MEETING AGENDA.....PLANNING BOARD
TOWN OF CORTLANDT
6:30 THURSDAY EVENING*
JUNE 5, 2025

With respect to the comments received from the Town Planner, Director of Code Enforcement and Town Engineer we offer the following responses:

1. *The Planning Division conducted a review of the subject application consisting of a 7-page set of drawings entitled "JAM Storage, LLC" prepared by Richard Williams, P.E. latest revision dated November 20, 2024.*

SHEET NUMBER:
CP 2

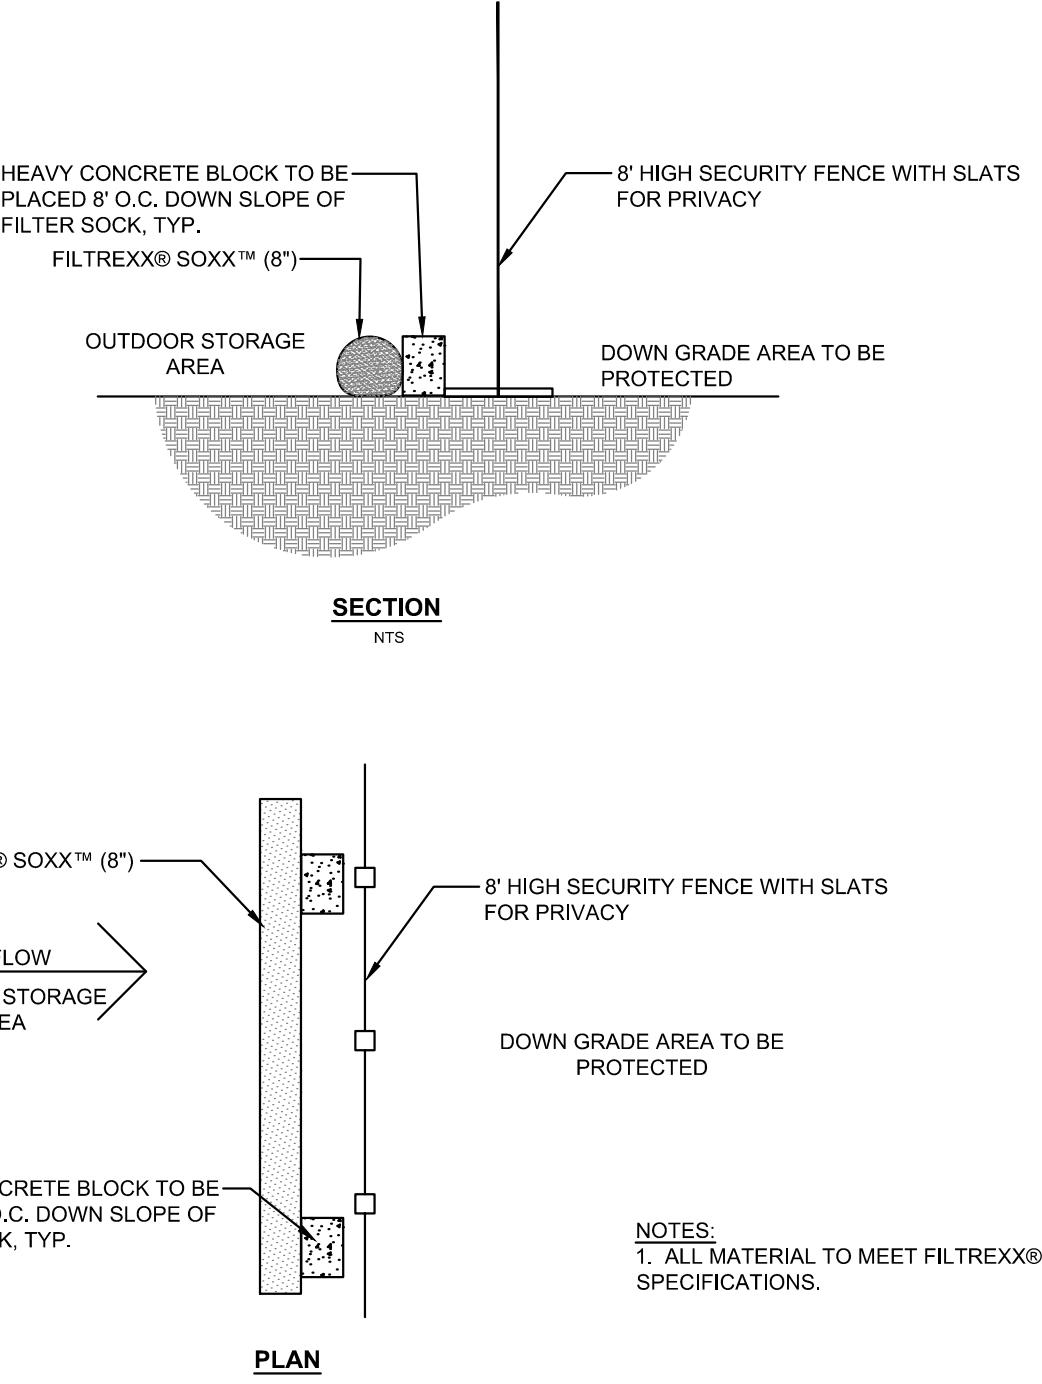
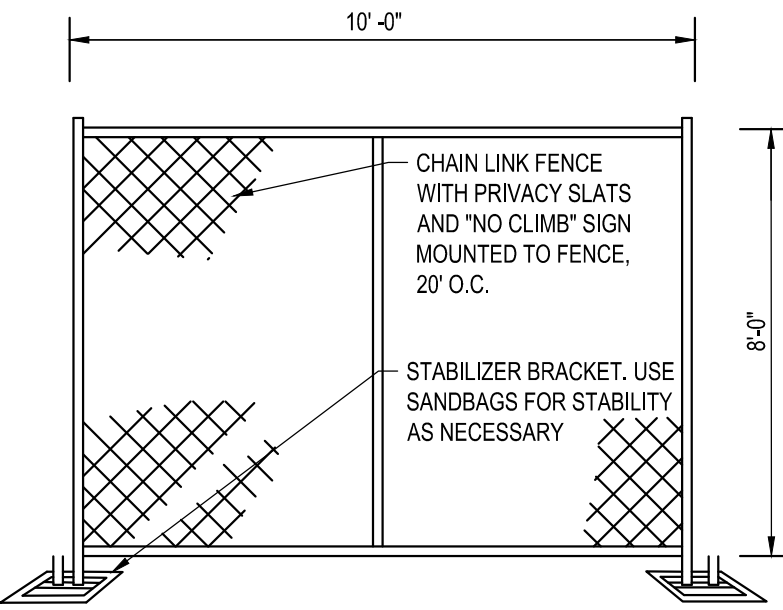
1. Fence shall be secured, slated for privacy and be "no climb". Fence height shall shown to a maximum of 8-ft. Detail accordingly.
2. Identify the type of goods and materials to be stored outside. .
3. Provide details for all proposed improvements including but not limited to erosion controls, fencing, shelving, etc...

4. Add the following notes to the plan:

- a. Walmart shall immediately notify the Town Center and Town of Cortlandt if any change to proposed storage of outdoor goods and trailers are proposed. No changes shall be made until approved by the Town of Cortlandt.
- b. There shall be no storage of flammable or hazardous materials in the trailers or within the confines of the storage area.
- c. Quarterly all site controls shall be inspected, with report provided to the Town of Cortlandt. Erosion controls and silt / filter socks shall be reset and all debris swept and removed from the storage area. All debris shall be lawfully disposed of offsite.
- d. Under no circumstance shall the main driveway aisles or fire lanes be blocked or obstructed, even for temporary delivery and offloading of goods and materials.

Please see attached revised plan for the Walmart exterior storage proposal. We will adjust if necessary and officially submit our plan and comment response letter in order to attend the 6/5 Planning Board meeting with a draft resolution.

DRAWING NO. **SP-3** SHEET 11

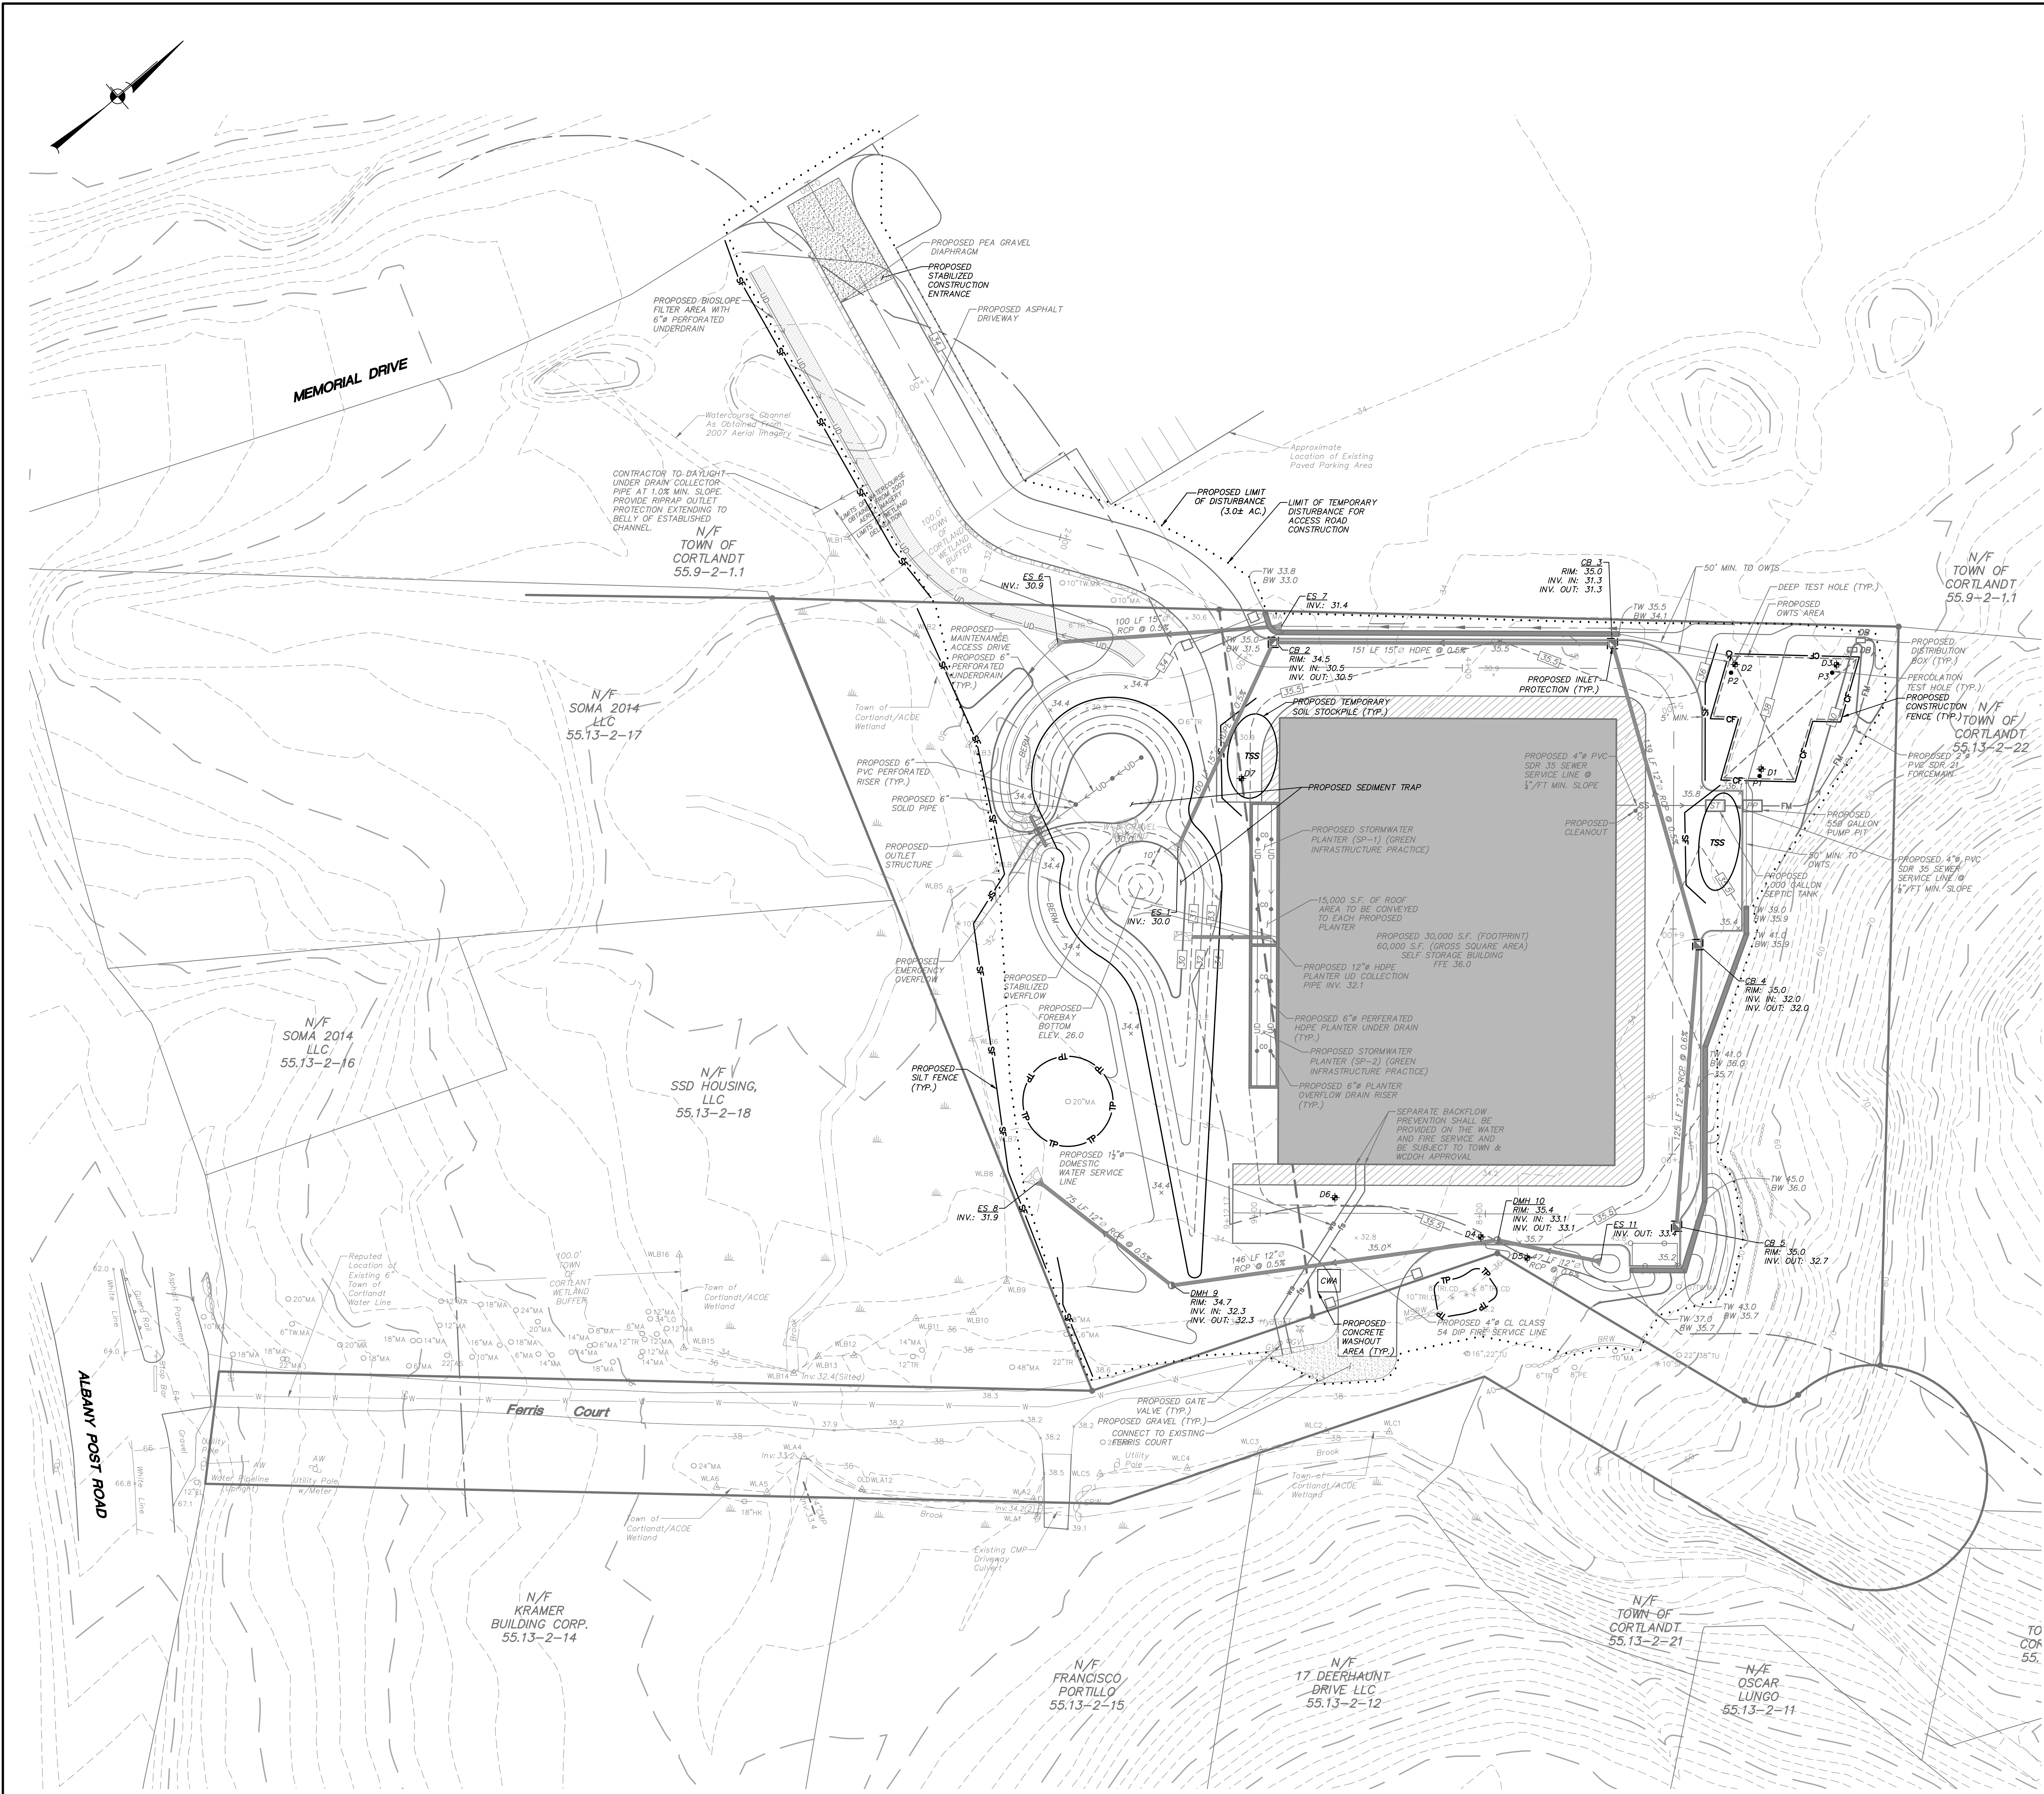
8. *Sheet SP-3 shows a temporary soil stockpile located within the wetland buffer near the proposed site entrance. Such activity is prohibited per §179-3.B.*

34. *Sheet SP-3 - Provide double row of silt fencing along the limits of disturbance associated with the construction of the retaining walls to ensure sediment laden runoff does not enter the wetland.*

35. *Sheet SP-3 - Remove stockpile area from the associated Town wetland buffer.*

36. *Sheet SP-3 - Label inlet protection at inlet grates.*

37. *Sheet SP-3 - Remove the callout for the concrete washout area.*

38. *Sheet SP-3 - The concrete washout detail indicates 100' separation from swales, inlets, and other surfaced waters. The proposed location does not meet these requirements. Relocate the concrete washout or provide an alternative design.*

39. *Sheet SP-3 - Provide an erosion and sediment construction sequencing schedule for the proposed development. Include in the construction sequence how post developed stormwater management practices will be protected during construction.*
